**TITLE:** USE PERMIT NO. 05006, Grainger Heights, requested by Kent Seacrest on behalf of Southview, Inc. and Ridge Development Company, for authority to develop 130 townhome units, with associated waiver requests, on property generally located northwest of the intersection of South 40<sup>th</sup> Street and Yankee Hill Road.

**LINCOLN CITY/LANCASTER COUNTY PLANNING STAFF REPORT**

**PROJECT #:** Use Permit #05006

**PROPOSAL:** A request for a use permit to allow 130 townhome units.

# GRAINGER HEIGHTS SITE LANDSCAPE PLAN

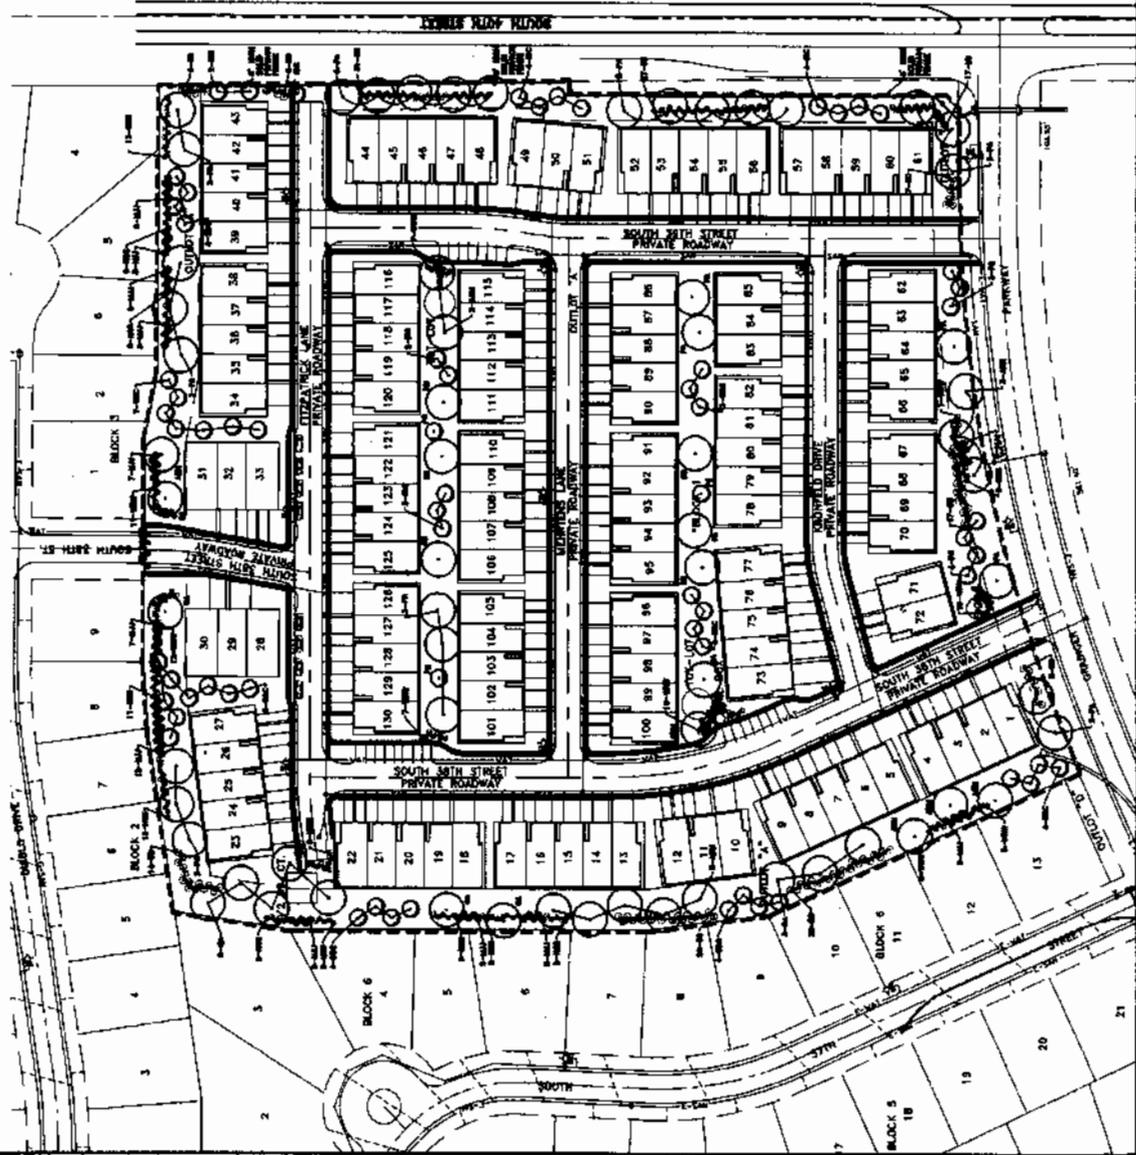
- 1.1.5 Revise the landscape to comply with the City of Lincoln Design Standards Chapter 3.50(7.6).
    - 1.1.6 Change the names of Shelford Lane and ~~Irwin~~ Kirwin Drive.

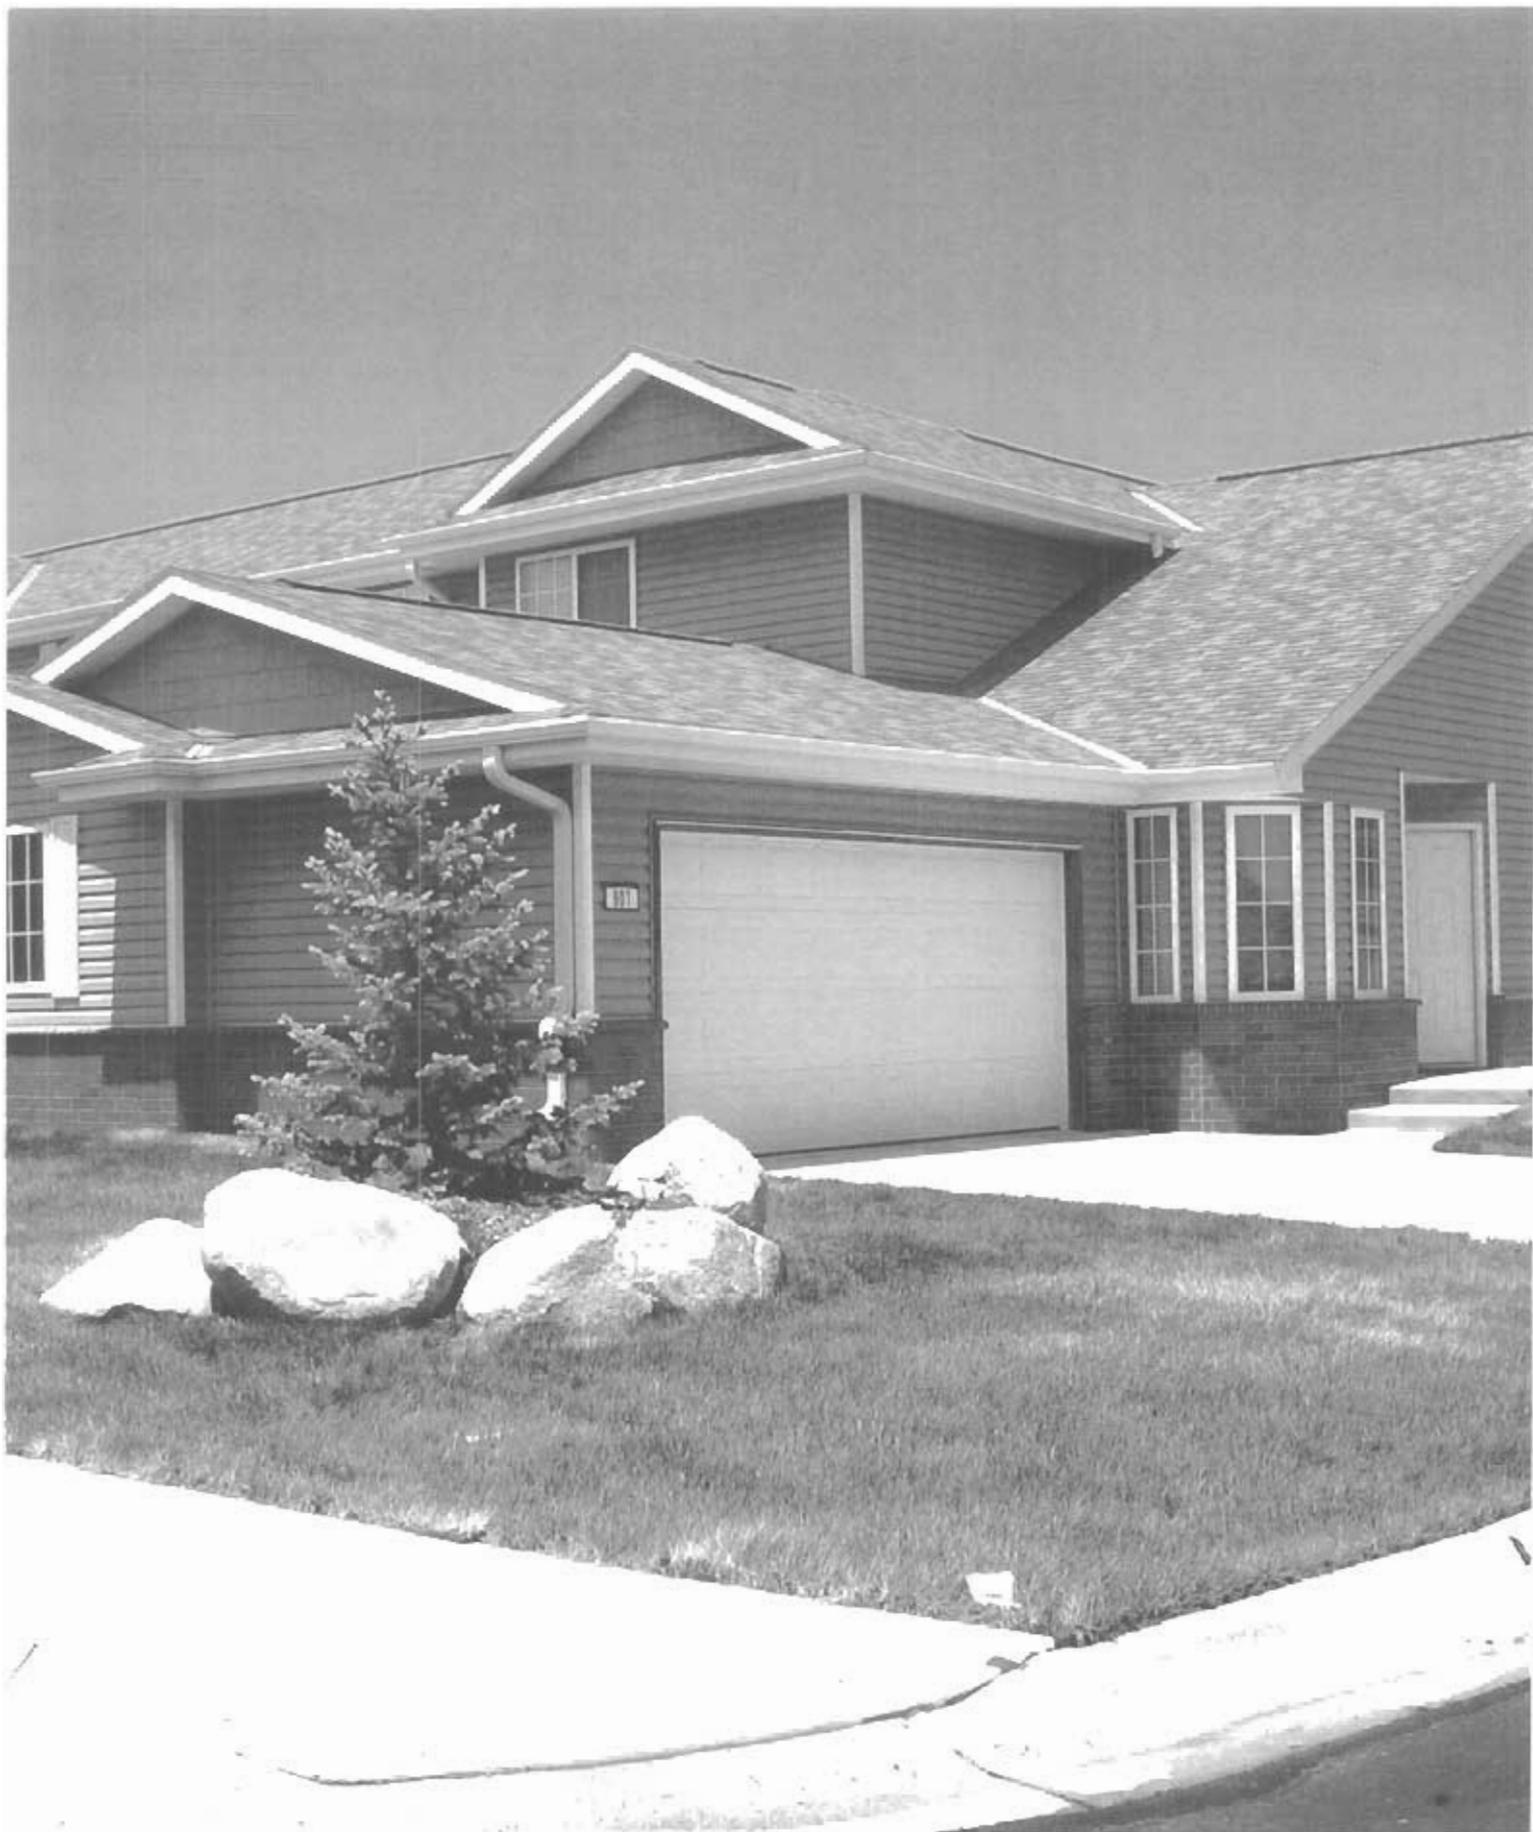
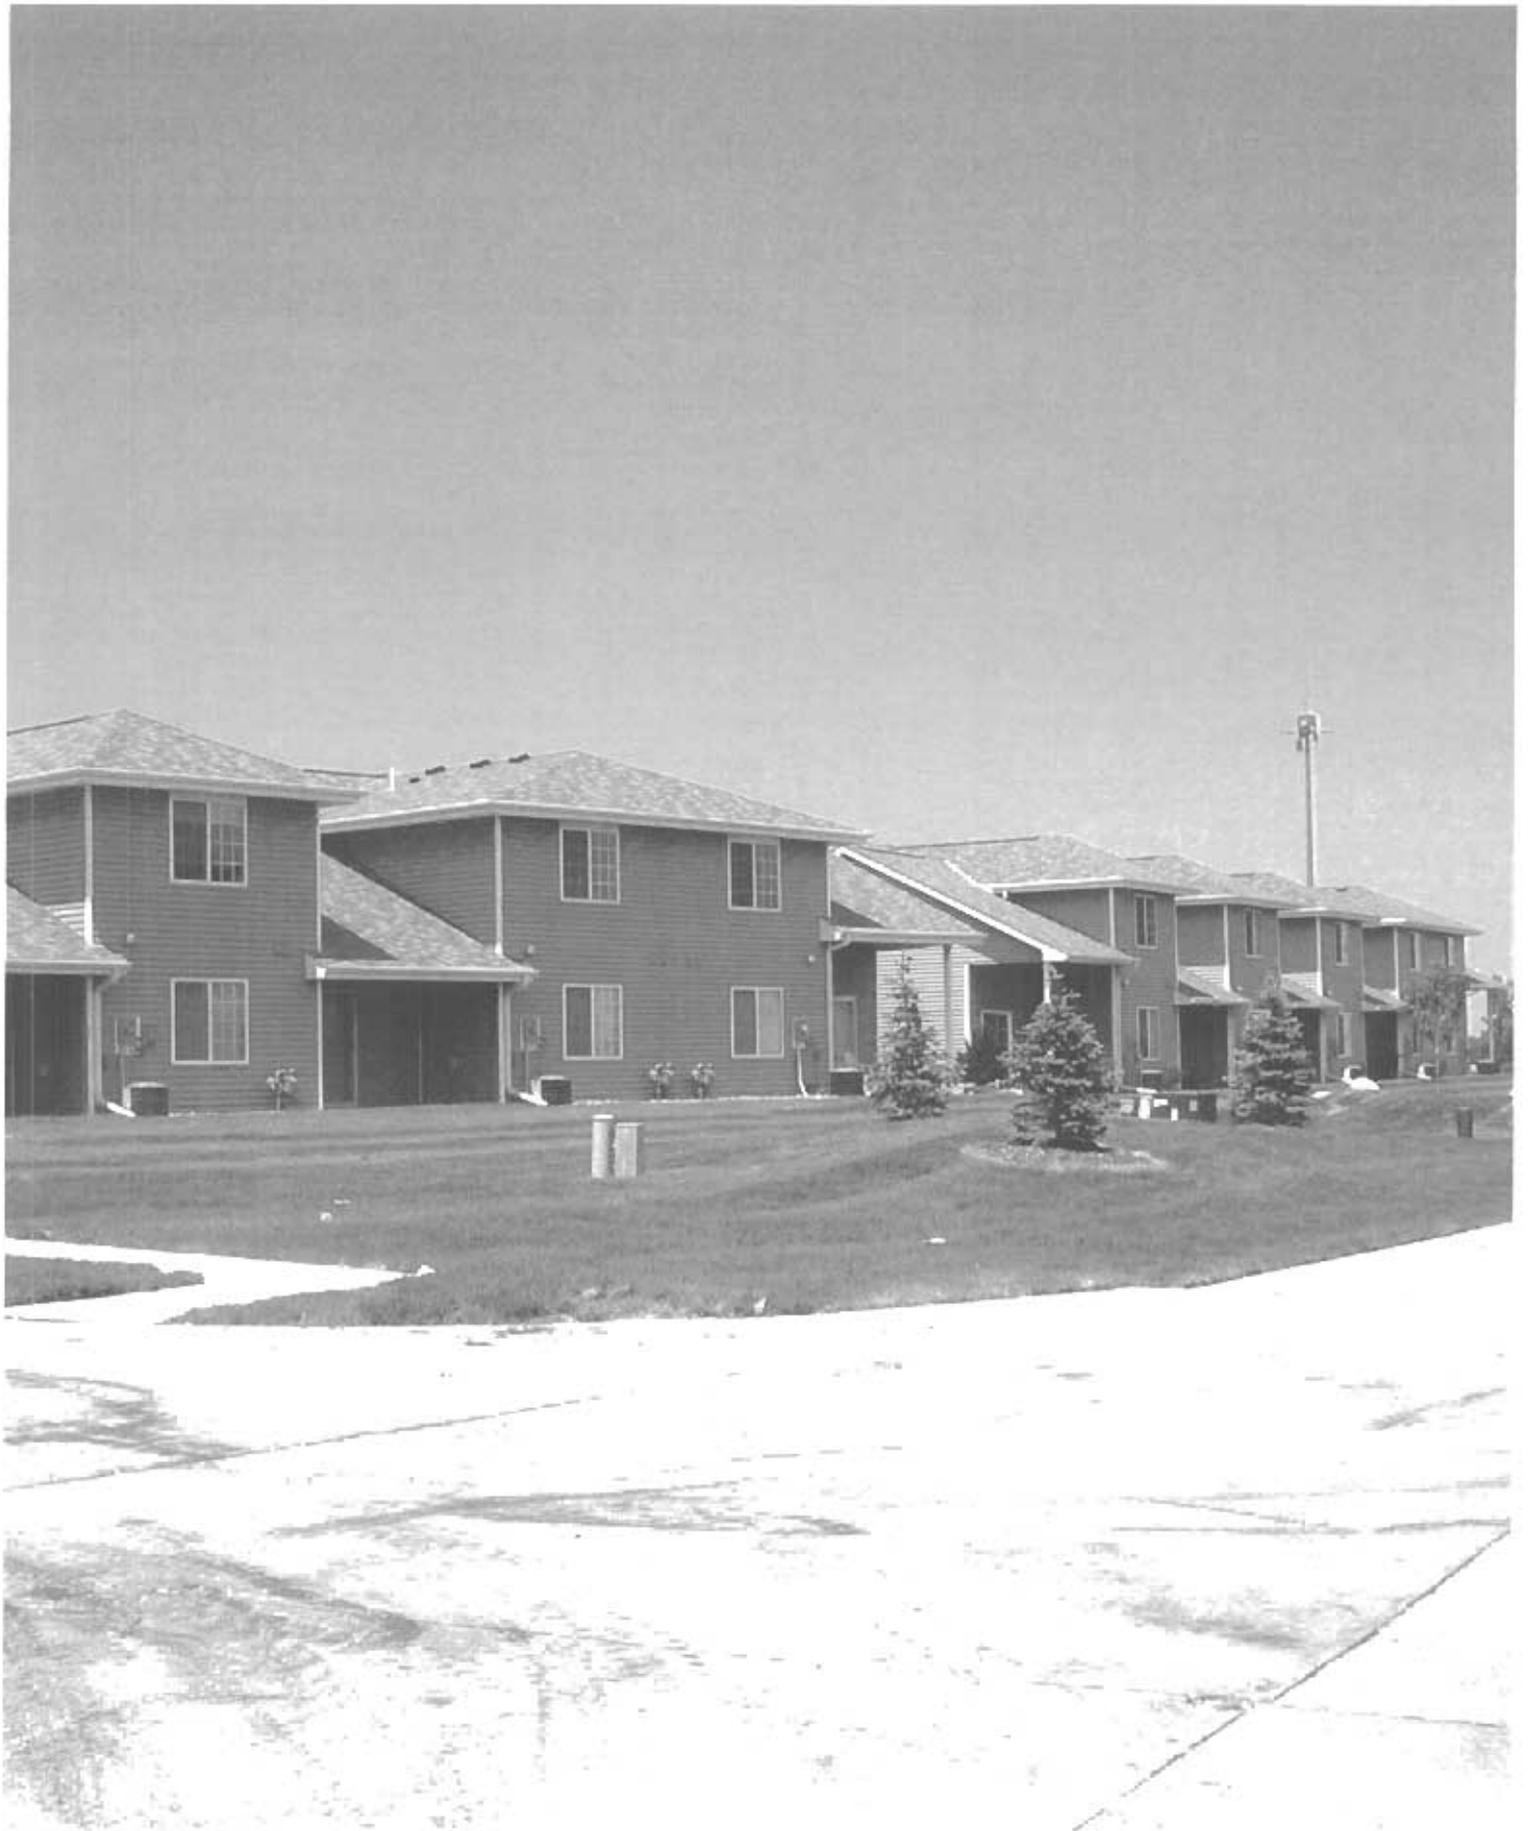
- 1.1 Revise the site plan to show:
    - 1.1.1 ~~Rotate~~ Shift Lots 28 -- 33 ~~so they to front onto Fitzpatrick Lane and relocate to provide a 40' setback from the residential lots to the north and show how the 12 parking spaces will be replaced.~~

- 1.1.2 Delete the connection of Fitzpatrick Lane to South 40<sup>th</sup> Street unless the City Council approves it, in which case a 200' long right-turn lane must be shown in South 40<sup>th</sup> Street.

- 1.1.3 The recreation area more centrally located or provide an additional recreation area at the southeast portion of the site. The recreation facilities to be provided to the satisfaction of the Parks and Recreation Department.

- 1.1.4 Relocate the sidewalks along east side of South 38<sup>th</sup> and the west side of South 39<sup>th</sup> Streets to provide an 8' setback from back of curb, and along both sides of the South 38<sup>th</sup> Street connection at the north boundary of the development. ~~Show sidewalks in South 38<sup>th</sup> Street~~ aligning with existing sidewalks in Pine Lake Heights 15<sup>th</sup> Addition. Show continuous sidewalks extending around parking areas.
